802 PINE

#3024239

FEB 6 2018

DRB RECOMMENDATION MEETING

TOWER MASSING & CONTEXT: IA & IB

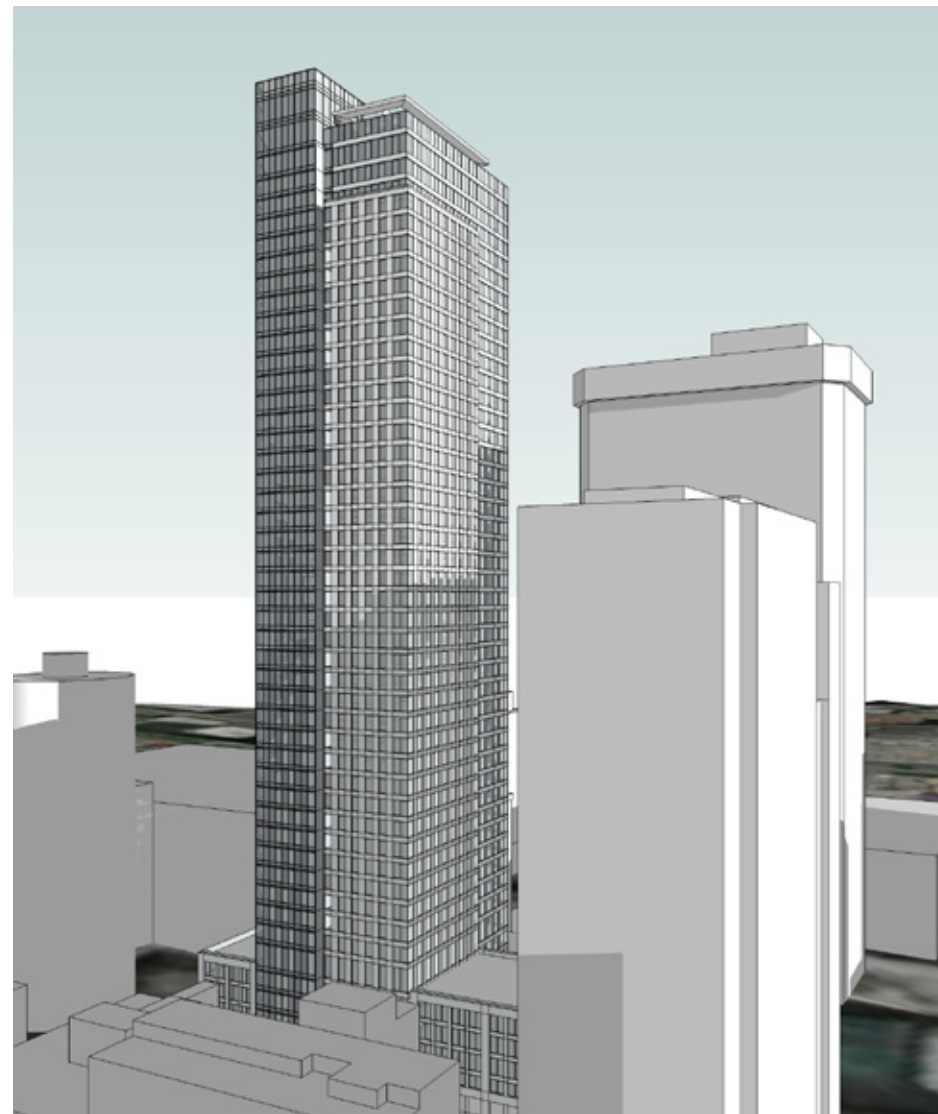
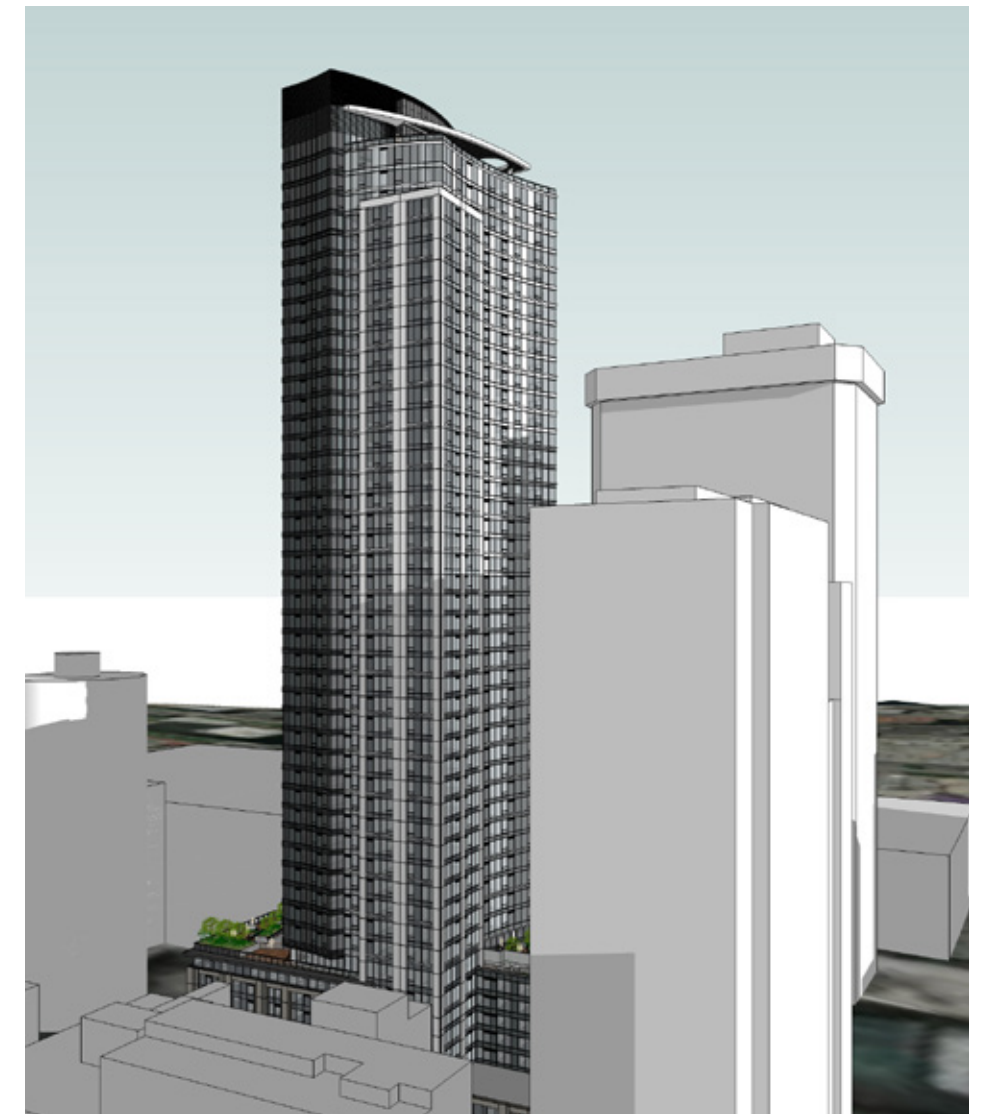
Ia. The Board understood the unique challenges from the existing transit tunnel easement on the southern portion of the site and how this impacts the location of the tower. The Board agreed with public comment about tower separation and supported the tower location closer to Pine Street, creating maximum distance (90 ft was stated on pg 38) from The Olivian tower to the north.

Ib. The Board supported the curved massing of the Option 3 tower, but agreed with public comment that it looks applied in only one location, and ultimately keeps the tower from being a coherent mass. The Board recommended a tower form that is cohesive on all sides and from distant viewpoints, including from the north and east, which will be highly visible above the lower Convention Center Addition (proposed)

Response: The design team has placed the tower columns as close to the bus tunnel as would be allowed. This allows us to move the tower slightly closer to Pine Street, cantilevering the structure partially over the tunnel. To maximize the separation of towers, we elongated the west face of our tower, because The Olivian's facade is pulled back from the property line. This means we maintain a minimum of 82'-3" of separation corner to corner. The tower then pulls away from The Olivian with a concave curve which ranges between 89' and 112' of separation, with most of the tower in the 90-95' range along the curve. (See page 46 for Diagram.)

Response: The design team has used a series of concave and convex curves as a response to the contextual conditions as a mechanism to maximize the tower separation with The Olivian to the North. The design solution addresses the Board's concern for coherency and visual interest from the North and East.

TOWER MASSING & CONTEXT: IC

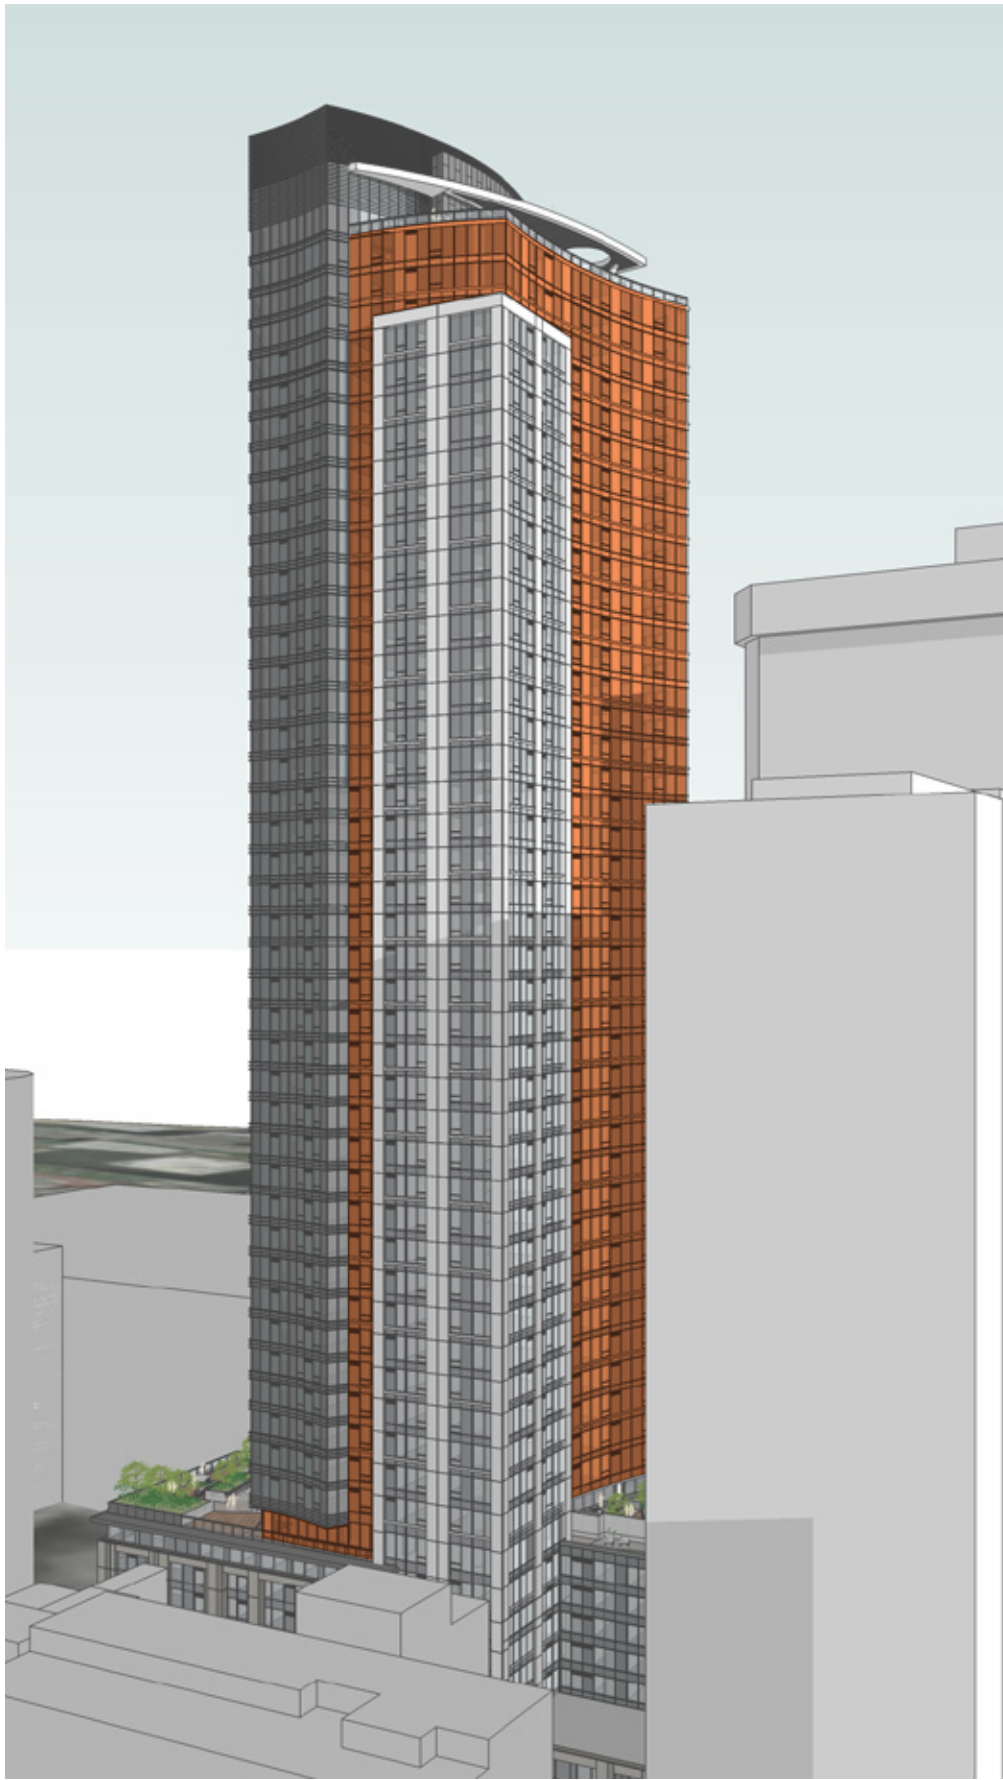
IC. The Board supported the notches shown on the east and west facades as needed modulation [32-34], but did not support the dramatic shift in façade language at those points [45]. Rather, the Board echoed public comment and stressed that coherence and unity should guide the design of all tower portions, and the Board encouraged study of a tower that displays curved and modulated aspects on all sides.

Response: The design team has reduced the emphasis of the notches and integrated them as one of the various methods used to modulate the building.

PODIUM CONFIGURATION: 2A

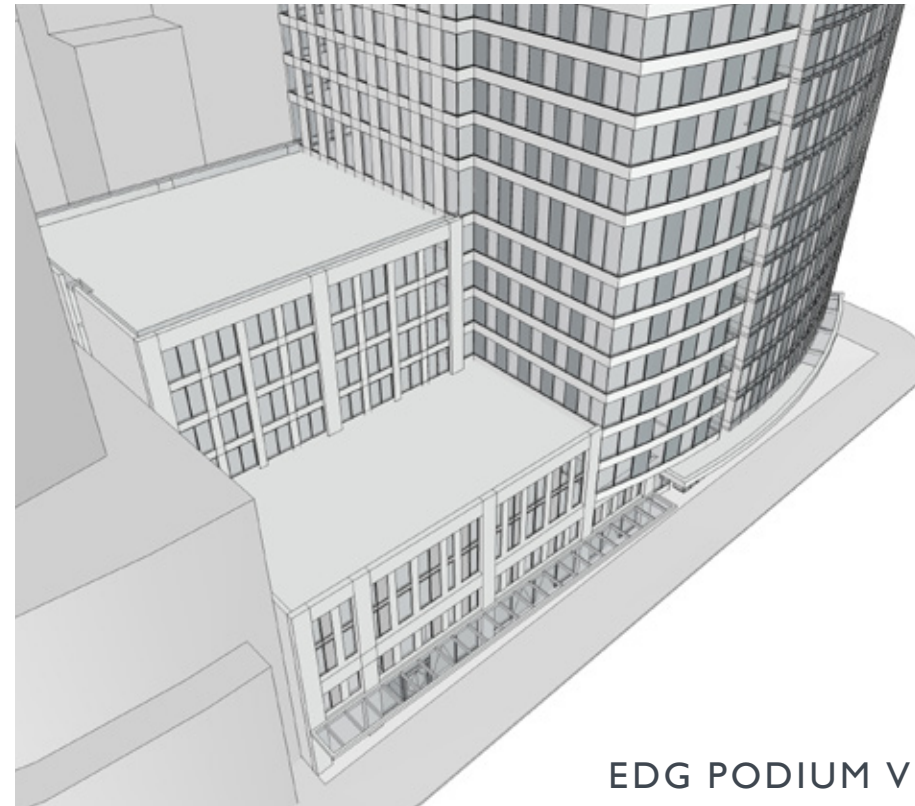
2a. The Board agreed the tower should lap the podium, but the joints and intersections between the two need more resolution with intentional reveals or other formal moves, not the simple collisions and penetrations shown.

Response: The proposed solution eliminated the podium massing set backs. This increases the strength of the podium in the massing scheme, which improves the interaction between tower and podium.

The primary tower corner at 8th and Pine slips by the Southern Podium form. A gasket of dark gray metal emphasizes the seam between the two forms, and elegantly becomes the upper story of the hotel podium.

PODIUM CONFIGURATION: 2A / 2B

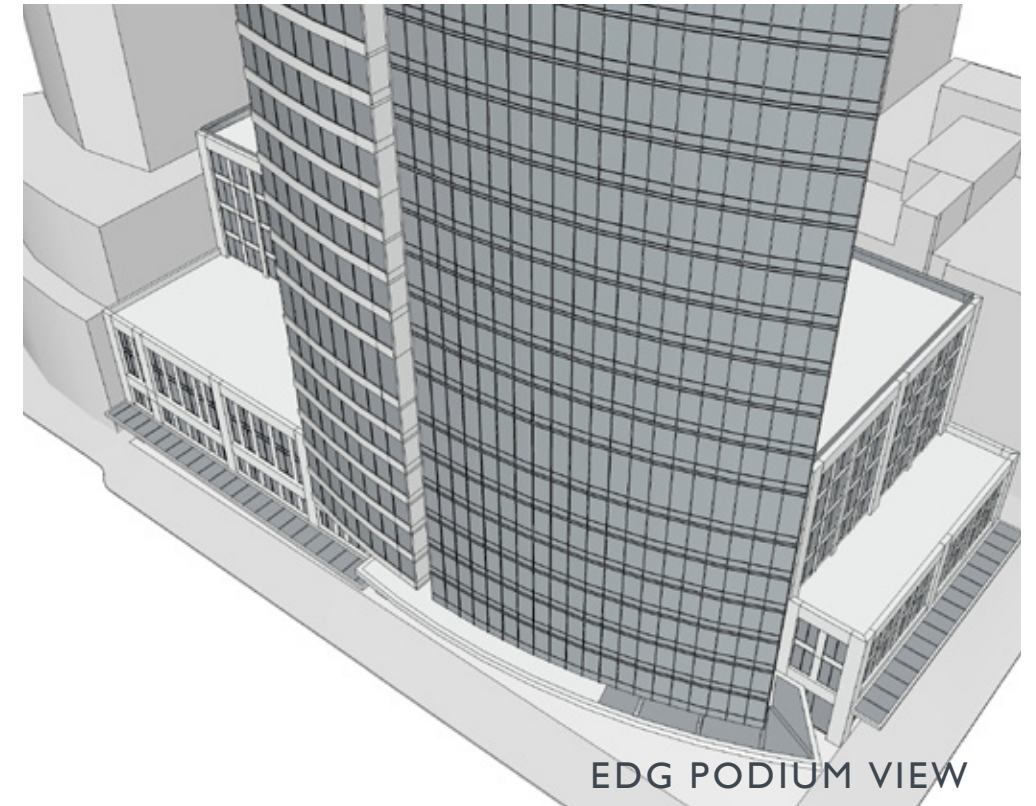
2a. The Board agreed the tower should lap the podium, but the joints and intersections between the two need more resolution with intentional reveals or other formal moves, not the simple collisions and penetrations shown.

2b. The Board questioned whether the two podium forms needed to step back at only 3-4 stories, or step back so far; pedestrian scale can be introduced in many ways besides short street walls. The Board also noted the exposed blank walls on adjacent buildings at the areas where the podium is stepped back. The Board recommended more study of podium form and step-backs, including datum lines and complete elevations of the adjacent buildings and surrounding context.

Response cont'd: Along 8th Avenue the tower's convex form and materiality of facade type B slips by a contrasting concave form with a darker palette. The hotel's framed entry piece plays off of both of these curvaceous forms, setting up a more rigorous street frontage.

Response: The design proposal abandons the setbacks along the fronting streets, and instead moves the setback to the alley side. This creates a stronger street frontage and allows the tower form to play off of the more robust podium. The convex tower form slips behind the concave podium form completing a curvilinear wave response to the Olivian's curving podium facade.

GROUND FLOOR PLAN: 3A

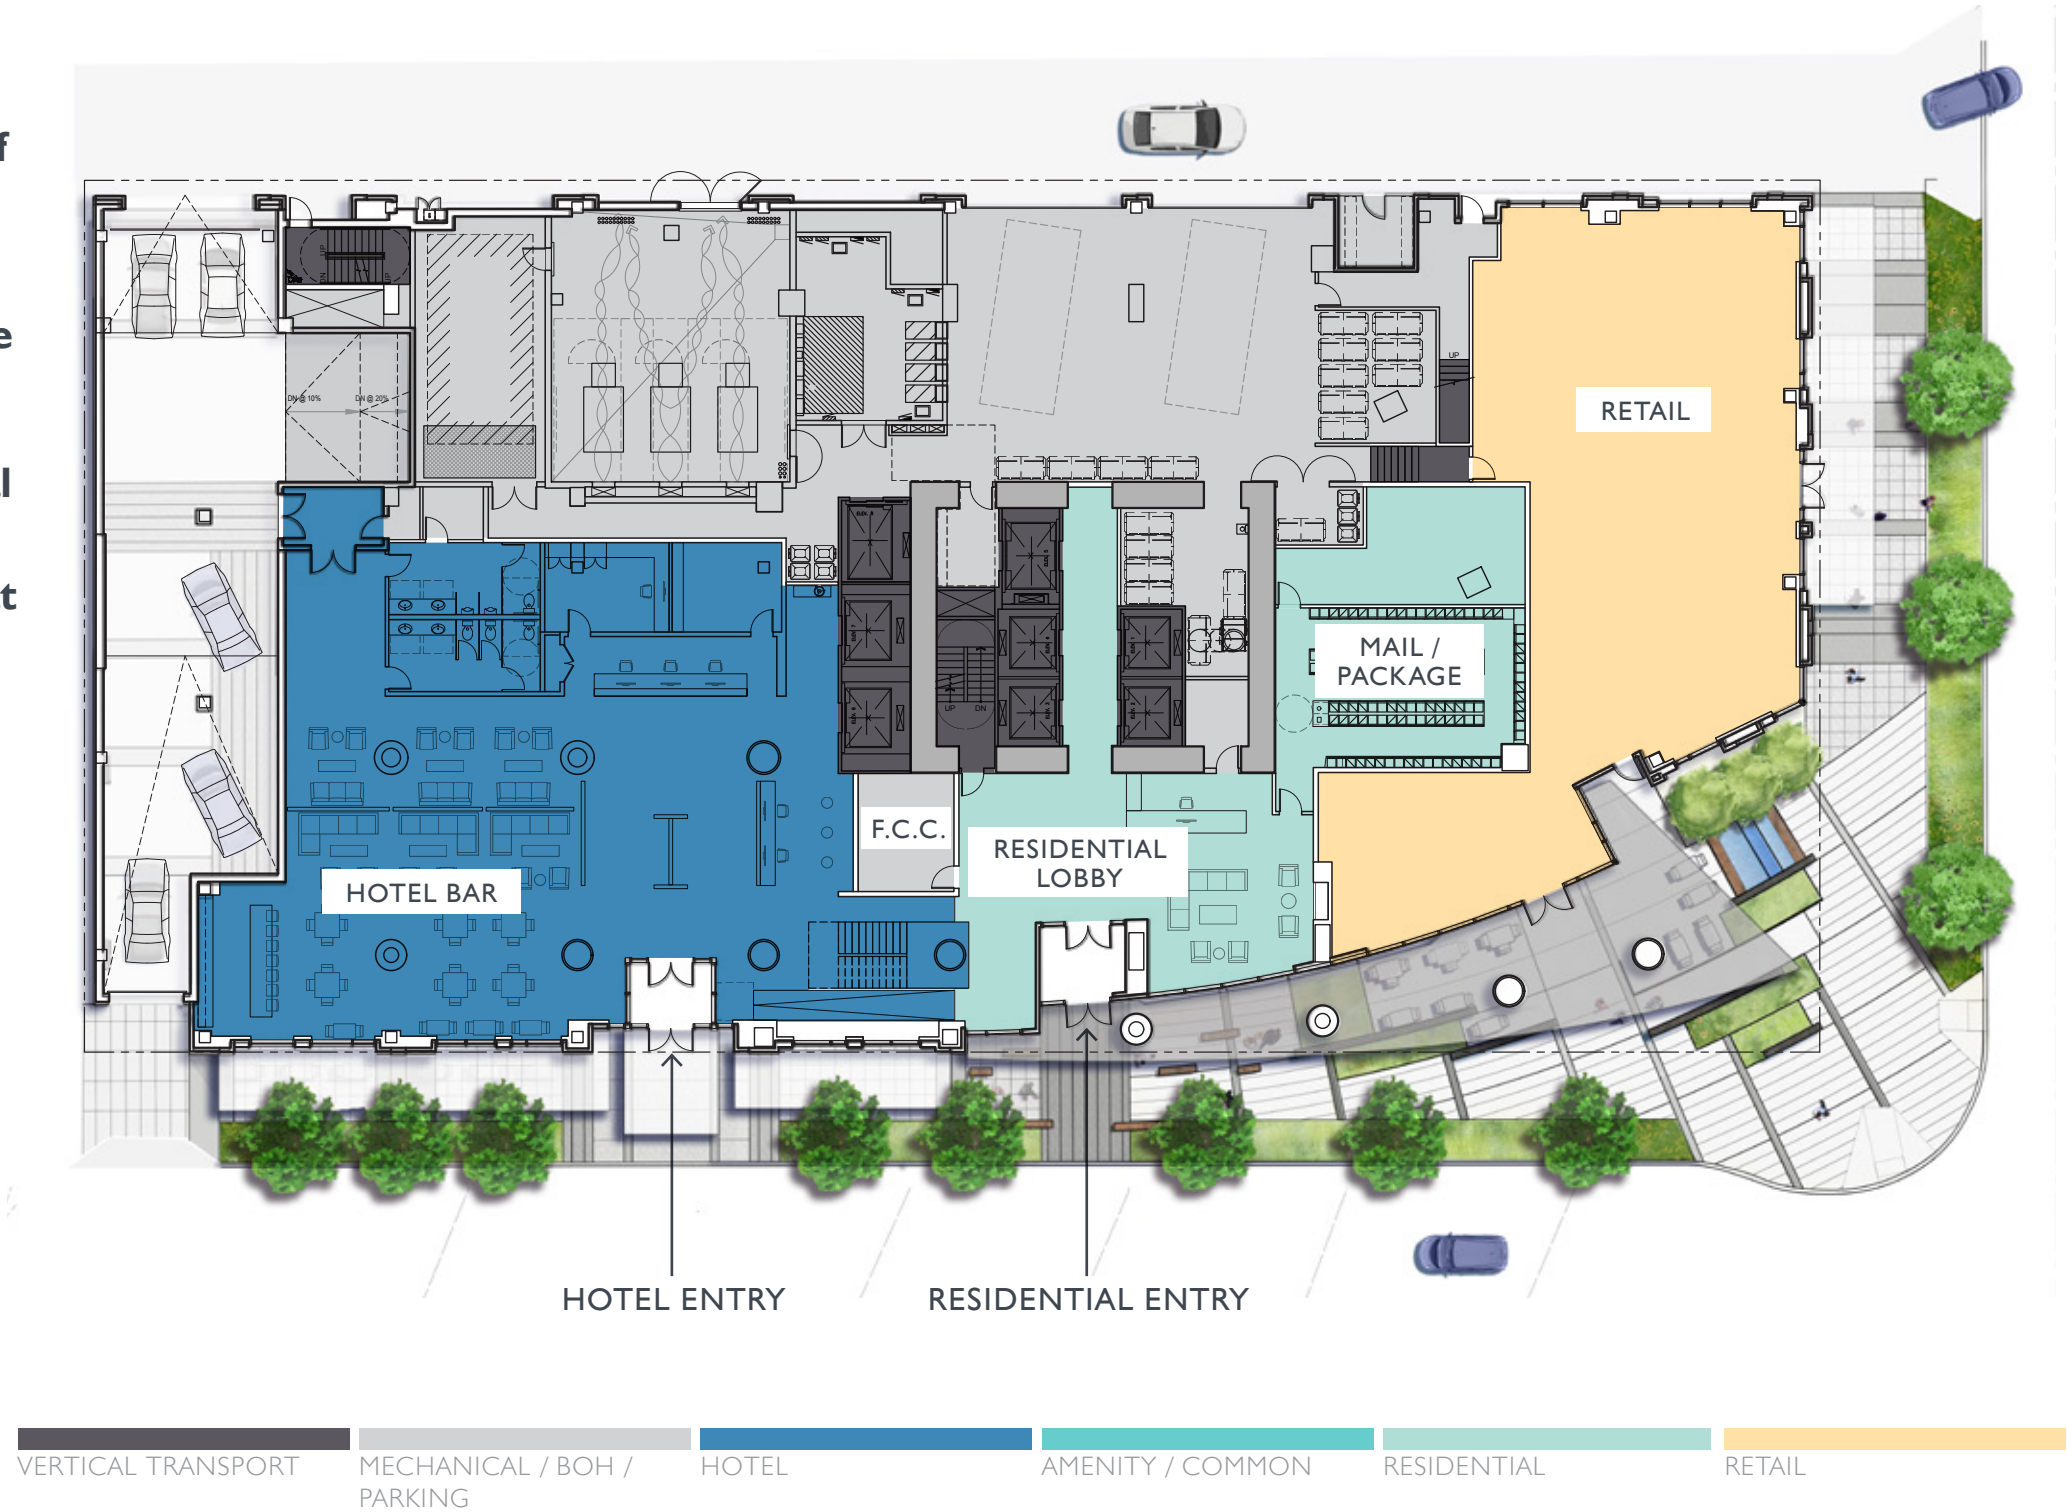
3a. The Board supported the generous and deep retail shown along Pine Street and at the corner, but questioned why the residential lobby needs to be as large as shown along 8th. The Board supported the floors stepping with grades, as verbally stated by the applicants, which affords maximum flexibility for door placements and tenant variations over time.

Response: The extent of the lobby has been reduced slightly, but it is important to note the importance of a functional sitting area, as well as a required F.C.C. room, concierge station and storage, as well as mail and package room access.

Additionally, the lobby for the hotel and lobby for the residential are open to each other, but at different elevations, so a portion of the size of the residential lobby previously shown was a “transition” zone between the two providing a ramp for the residential guests to access the hotel bar.

We have also added a stair accessing the ballrooms at Level 3. This stair is intended to be detailed in a way that brings elegance as a focal point from inside and outside the building.
